City of Surrey  
**PLANNING & DEVELOPMENT REPORT**

File: 7916-0214-00

Planning Report Date: May 8, 2017

**PROJECT:**  
MIX-USE DEVELOPMENT  
14418 & 14462 -72 AVENUE  
SURREY BC

DRAWING NO.:  
**A-501** | **H**

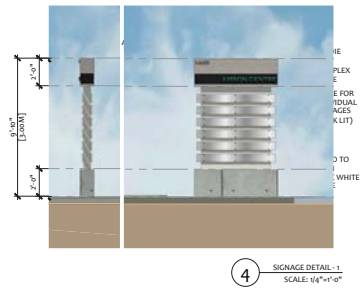
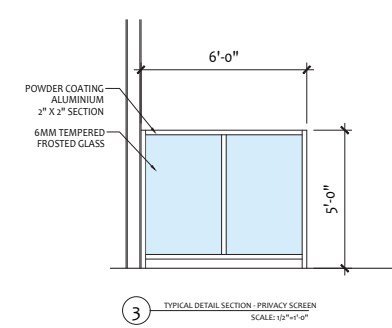
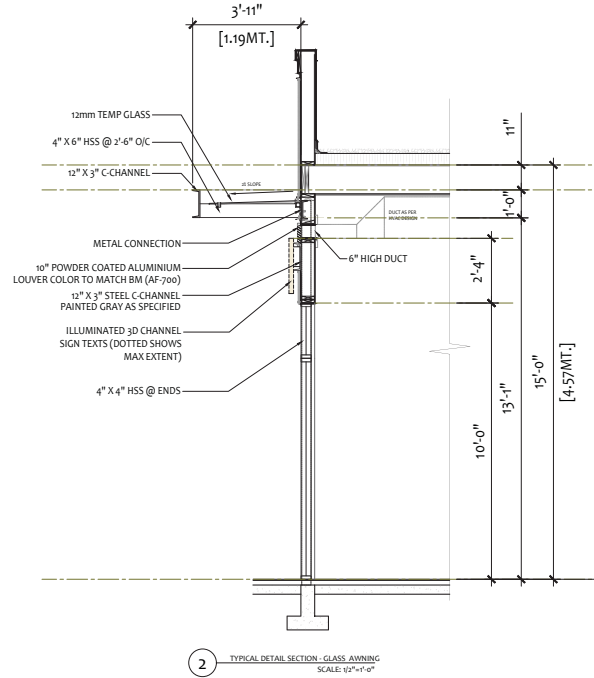
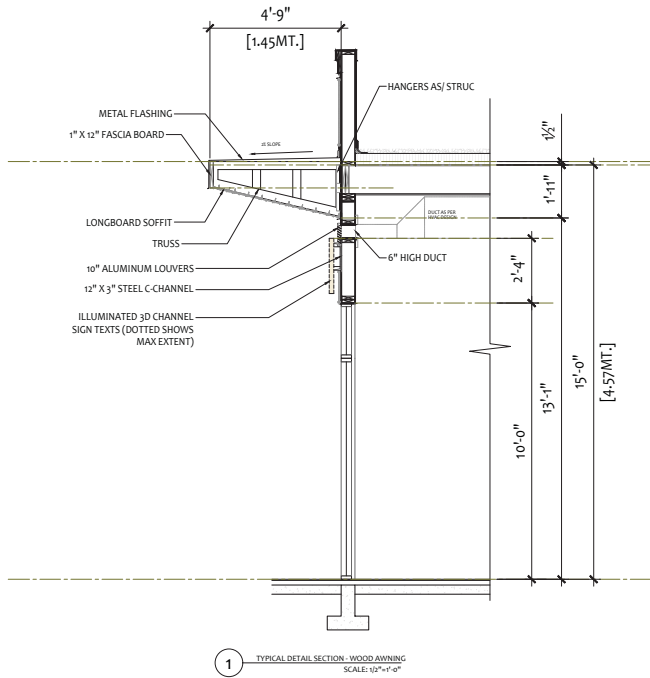
- Provide details of the weather protection canopy. Show the wood soffit canopies extended to 1.5 m and the glass canopies extended to 1.2 m.  
**Done. Refer A-501**

- Show that the gas metres are screened and located away from public interfaces. Provide details of the alcove in combination with flush-with-building custom screening.

**Noted. Refer A-501**
- Recommend canopies be placed low enough to provide sufficient weather protection.  
**Noted. Refer A-501**
- Consider accentuating changes in materials where it transitions to another on the same plane.

**Free standing signage height have been revised to 3.0 M as per the East Newton South NCP, Appendix C, 1.0 Design Guidelines. Refer A-501**

**Gas meters are screened now. Refer A-100.1 & A-501**
- On the elevation drawings, show the louvers/grille work proposed on the street facing facades and indicate where the functional ducts are located.

**Refer A-501 for typical elevation detail**
- Show a note on the drawings prohibiting roof top mechanical units on the drawings.  
**Noted. Refer A-110.2**

**1**  
**L3** **GARBAGE ENCLOSURE**

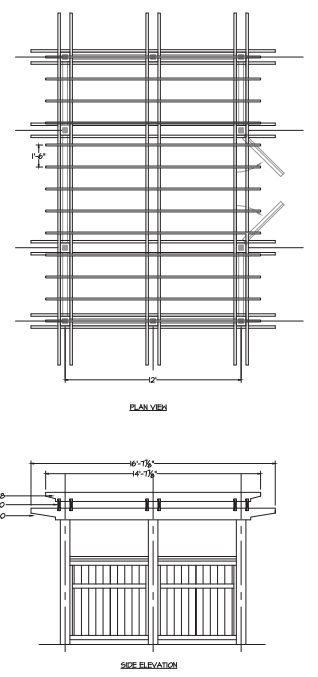
- The residential entrance way is meager. Suggest removal of a parking stall to create an entry way covering half the width of the stairs to sidewalk. If a parking stall cannot be removed to open the area up, the area could be specially paved or include something to help mark the area as special. The building entry could be indented more.
- Suggest the roof terraces be more ample, extending up to the edge of the roof.
- Suggest lowering the parapet for the south residential units’ balconies.
- Should provide details of privacy screens between south terraces.
- Recommend canopies be placed low enough to provide sufficient weather protection.
- Consider accentuating changes in materials where it transitions to another on the same plane.
- Consider location of garbage enclosure related to residential.
